Stability Pathfinder Phase 2 FAQ

Updated 18/12/20

This document contains the questions submitted at the RFI stage from July 2020. We have updated some of the responses to reflect the latest information. As the EOI progresses we will update this document with EOI webinar questions and common questions we are receiving.

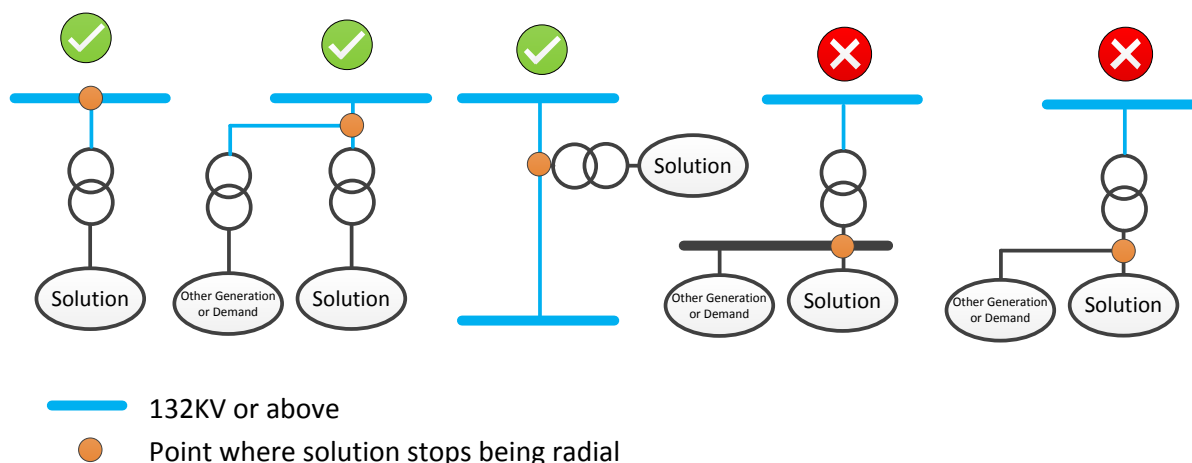
26. Why were these 8 locations picked? (added 06/11/20)

This is based on our system needs and studies. See Q13 for more information.
